Assessment Officer Report

PA2503747 – 675 Victoria
Street, Abbotsford

Planning Assessment Officer Report
Development Assessment

Figure 18: Proposed streetscape (Source: Application)

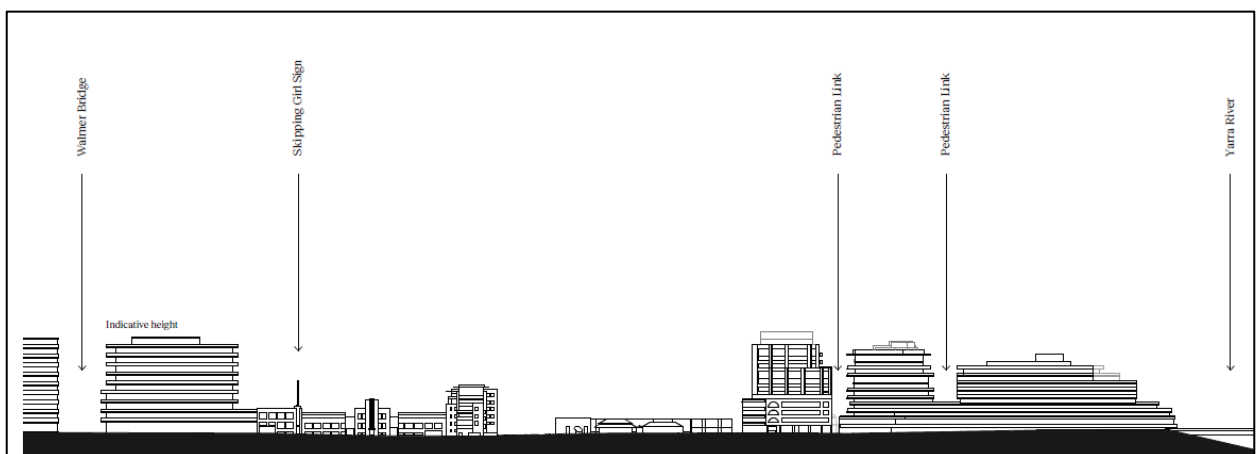
115. The council has recommended that the building height be reduced by two storeys (one level between Levels 7-9 and Level 10), due to the site's mid-block location and overall size of the site and to be consistent in height with the existing building to the east. On balance, it is considered that the proposed height is acceptable for the following reasons:

- The height is generally consistent with the existing and emerging built form along Victoria Street;
- The proposed design is of high quality and will provide interest in the streetscape;
- The proposed through block pedestrian link provides a public benefit to the site and the wider community;
- The recessed double storey glass 'crown' is differentiated by the masonry form below, to assist in minimising visual bulk;
- The built form massing and articulation with the variation of materials and the stepping down / terracing of the building towards the northern river interface, balances and integrates the massing of the proposal with its surrounds; and
- The proposal includes an extensive landscaping regime to the northern interface (including balcony and terrace plantings), to provide a landscaped interface to the river, as sought by the SLO1.

Figure 19: Encroachments into mandatory setbacks (Source: Application)

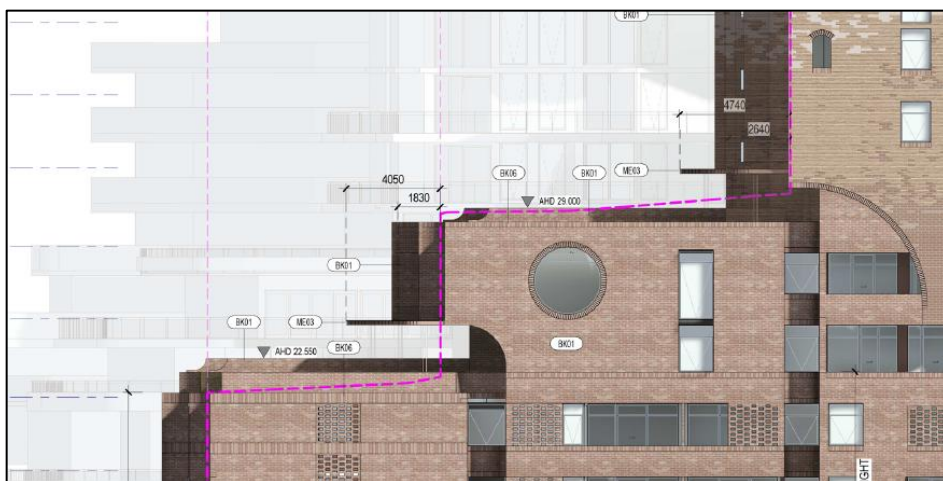
116. It is noted the Level 1 northern terraces and the wind canopy projections located above the Level 1 and 3 northern terraces, encroach into the mandatory height requirement of the DDO1-G, as shown below.

117. It is considered that a projection is not prohibited within these setbacks, provided the projection does not contribute to the building height at that point. The Yarra Planning Scheme defines building height as *'the vertical distance from the natural ground level to the roof or parapet at any point'*. As such, balustrades and canopies are not considered part of the building height and these projections are permissible and supported.

Figure 21: Pedestrian link in the north east corner (Source: Application)

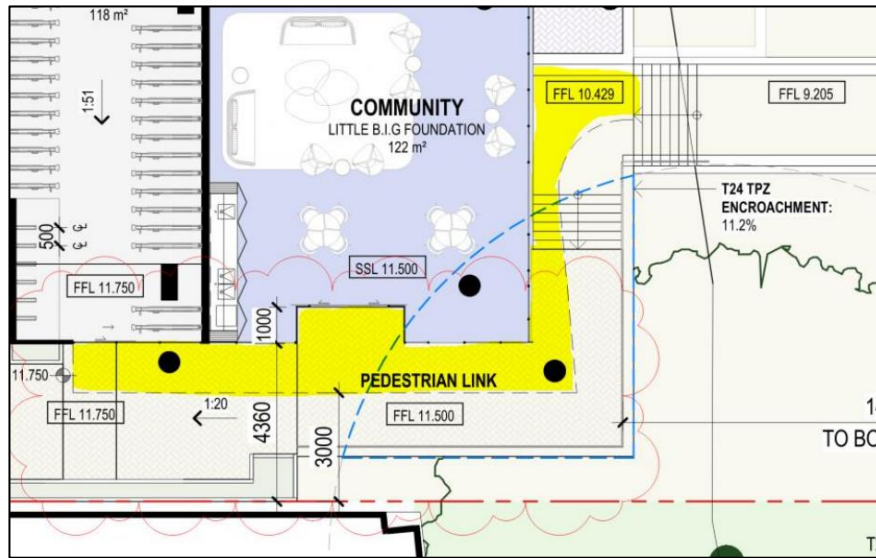
126. It has been raised by the council and DTP's Urban Design that the pedestrian link should be either clear to the sky or double height for its entire length. The portion of the link that is not double height is shown in the figure below and is associated with dwellings on the Ground and Upper Ground Levels.

127. The reduced clear to sky design for this section of the pedestrian link is considered reasonable. The remainder of the link will remain open to the sky and the entire link will include appropriate lighting to ensure the space remains safe and easy to navigate.

Figure 22: Proposed tree removal (Source: Application)

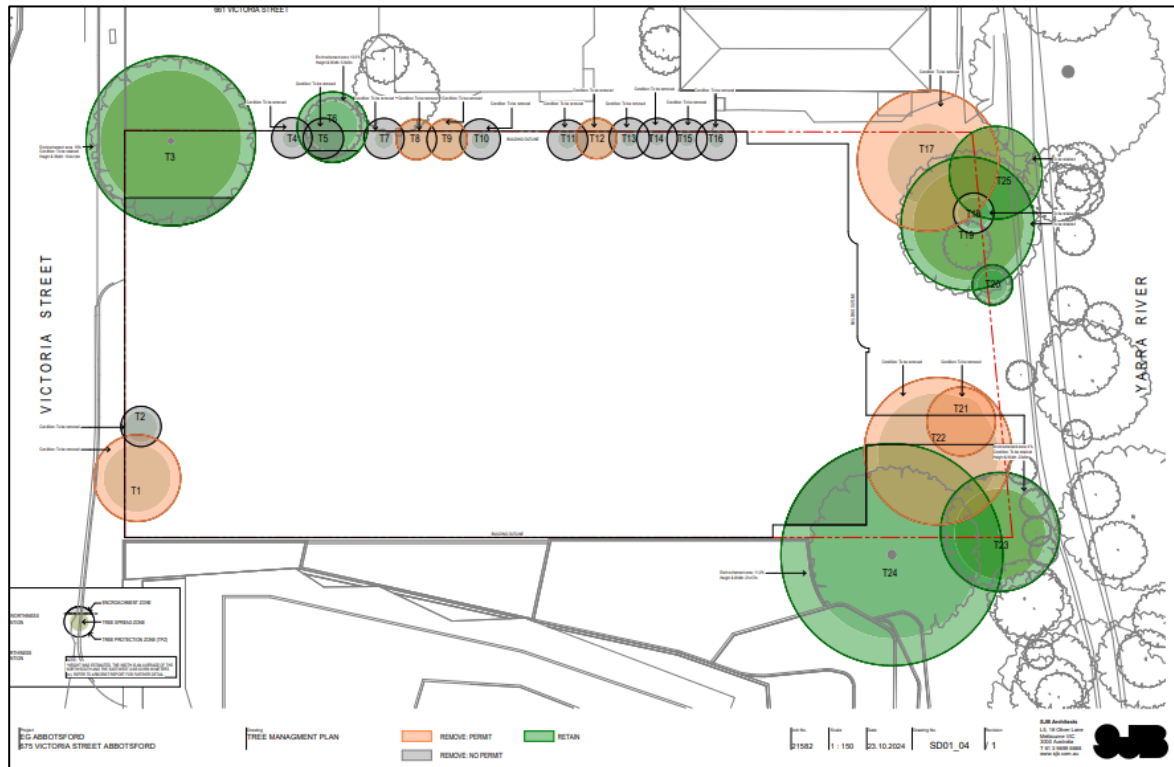
- *Tree 22 is a Corymbia maculata (Spotted Gum), this native tree is bifurcated close to its base with three acutely attached trunks, with included bark and kino bleeding at the largest of these points, see Appendix 4. This is an underlying structural fault that would result in stem failure if no major pruning is undertaken. If major pruning is undertaken, it will reduce this potential for a stem failure to occur; it cannot eliminate this potential. In particular as this tree continues to grow taller, the wind loading on such poorly attached stems would exceed strength at this point and result in a stem failure. This tree is inappropriate in this position in the long-term and has therefore been marked for removal and replacement with a more suitable and structurally sound tree. A tree that will enhance this landscape now and the wider landscape in the long-term.*

136. Given the above description of the trees and the location of the staircase (designed in consultation with Parks Victoria), it is considered the removal of trees 21 and 22 is reasonable.

Figure 24: Council's flood mapping (Source: Yarra City Council)

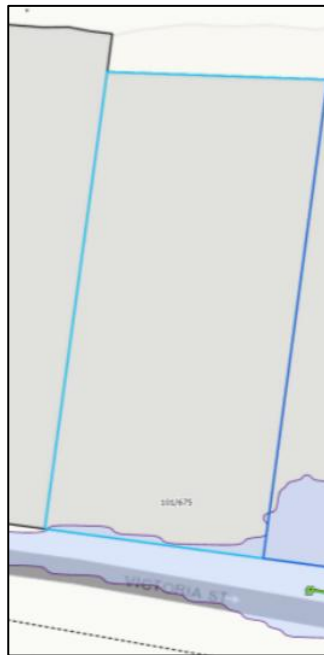
145. The council have also advised that their own flood mapping indicates that the site may be subjected to flooding during a 1 in 100 rain event from surface water in Victoria Street, which is depicted below:

146. The council identifies the 1% flood height maximum as RL14.52 and the 1 in 100 year ARI as RL14.4 along the frontage.

147. The council has further advised that they are generally satisfied with the basement ramp apex height (at RL14.75) and require the south-east corner of the ground level of the office to be either flood-proofed or have the sill level set at a minimum RL14.75 and the level of the pedestrian link to provide a freeboard height of minimum 150mm above the applicable flood level to prevent surface water from Victoria Street entering the site.

Figure 25: Shadow study 22 September 10am (left image) and 11am (right image) (Source: DTP)

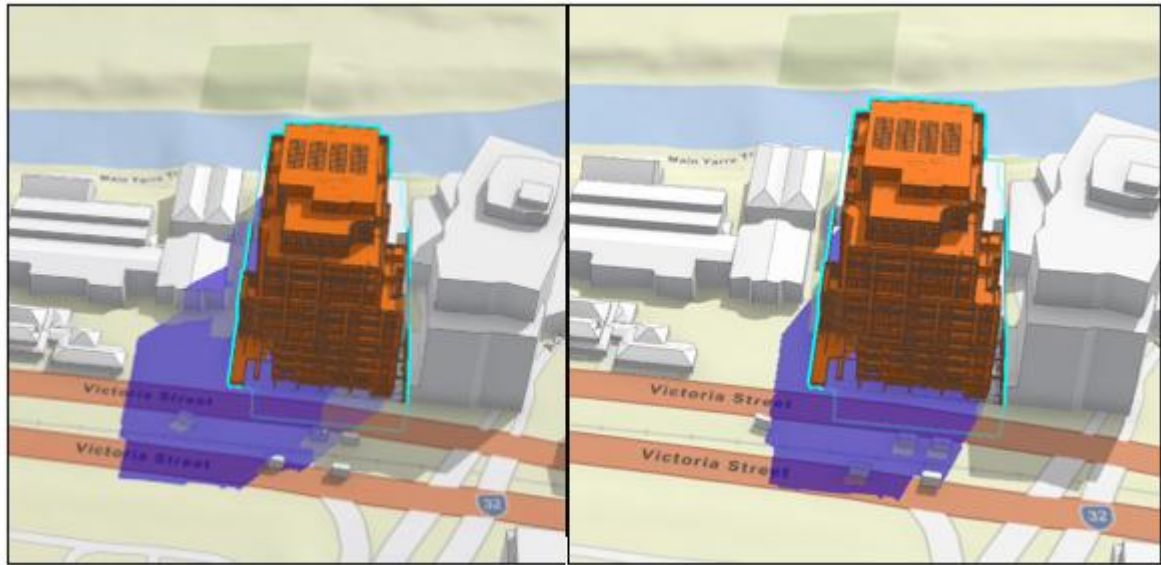
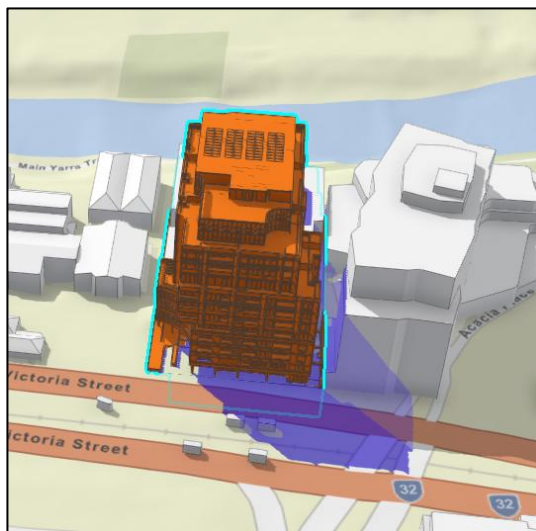
161. The figures above show that the proposed building will cast additional shadow over the southern footpath of Victoria Street at 10am. Noting that any built form on the site will create additional shadow to the northern footpath along Victoria Street, it is considered that this additional shadow to the southern footpath is not unreasonable in this Major Activity Centre context.

Figure 28: Living room windows to be redesigned / screened (Source: Application)

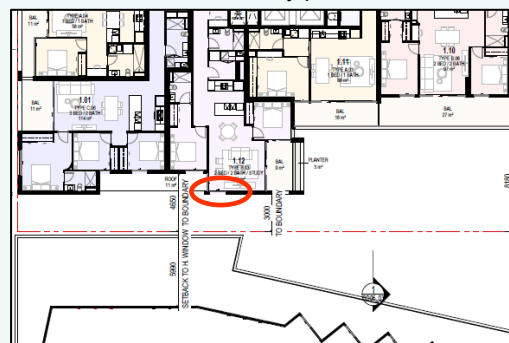
There is potential overlooking between the proposed building (specifically the south east corner) and dwellings in the building to the east. It is important to highlight that this standard does not contain any reference to restrict looking within a distance of 9 metres, as occurs under Clause 55 provisions. Instead, a development is expected to limit views or avoid direct views into private open space. It is further noted that Clause 55 does not require screening of bedrooms.

As such it is considered that the living room windows along the east elevation of dwellings 1.12, 2.12 and 3.12 (highlighted in red below) should be designed / screened to avoid direct views into the private open space of the dwellings to the east. This can be included as a condition on any permit to issue.
